Red-Line Revision [2]

MD 146 (Dulaney Valley Rd) @ Dulaney Plaza and Towson Town Centre North Entrance

GENERAL INFORMATION PLAN

TS NO. 4574A-GI | DRAWING – OF | SHEET NO. 4 OF 4

Wiring Diagram

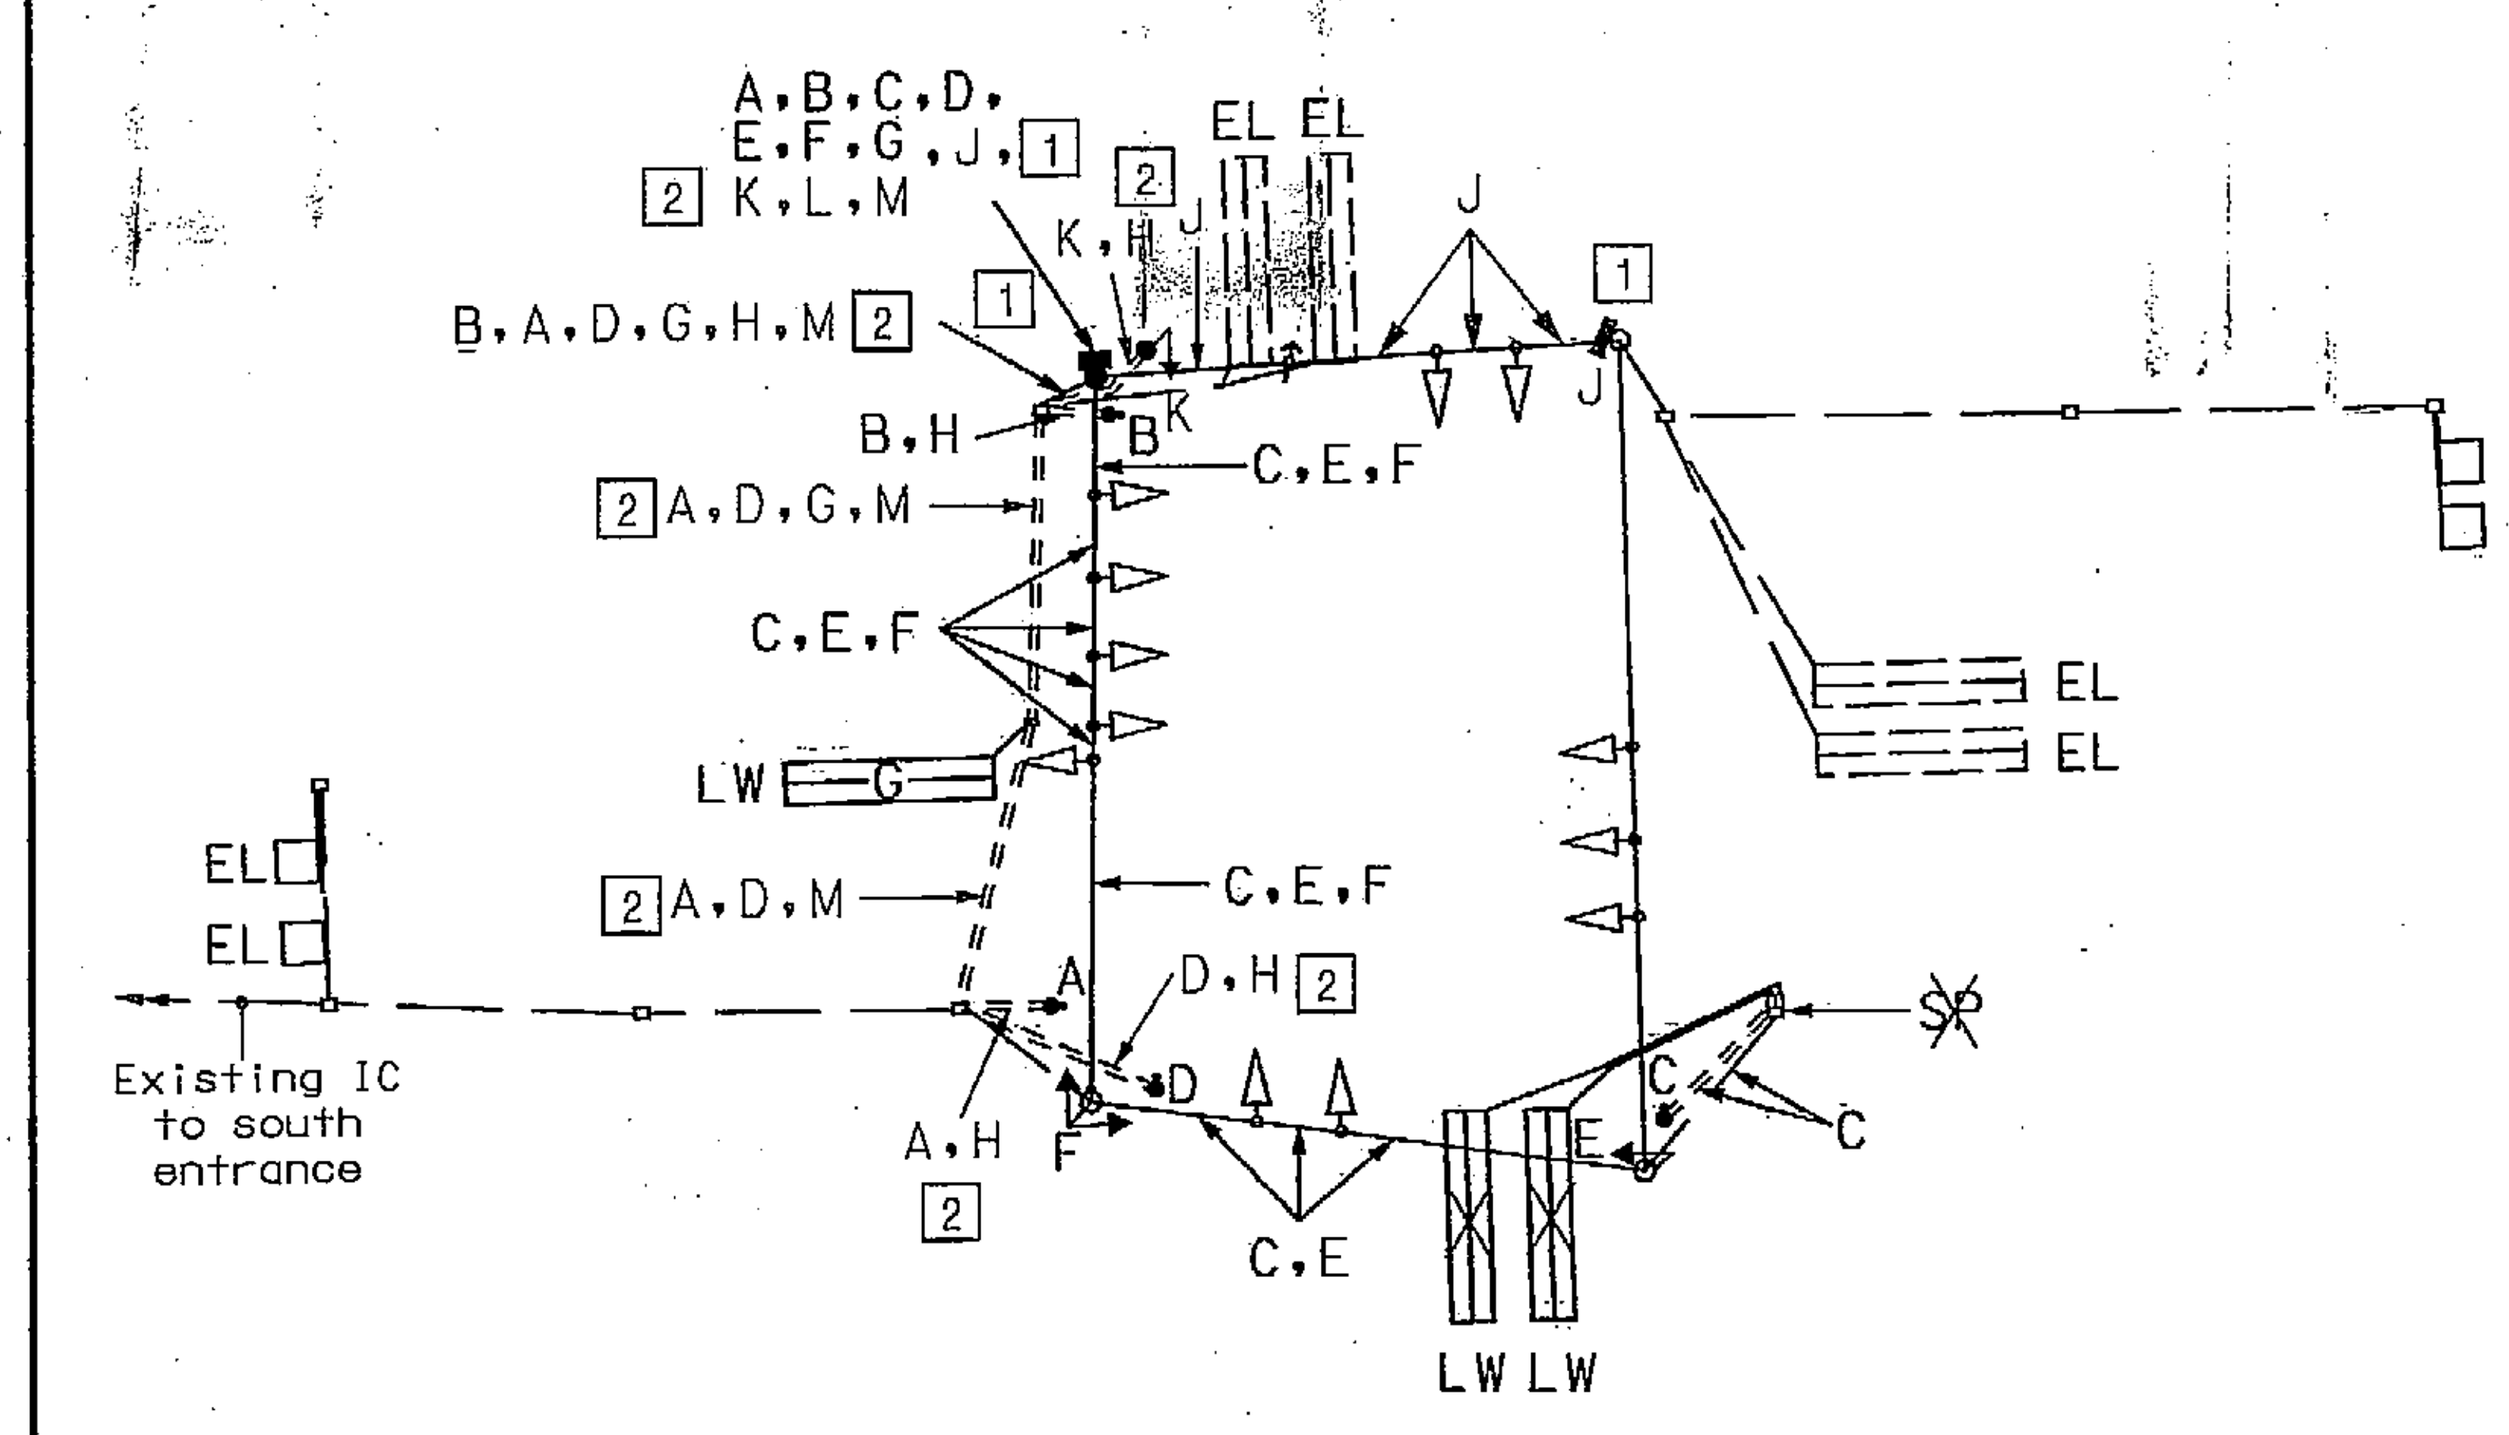
E, F, [2] K — 5-Conductor Electrical Cable (No. 14 A.W.G.)

[1] J — Video Detector Cable

[1] ✱ — ~~Splice Loop Wire To Existing Aluminum Shielded Cable~~

[2] M — Existing Interconnect Cable (North Entrance - South Entrance Run)
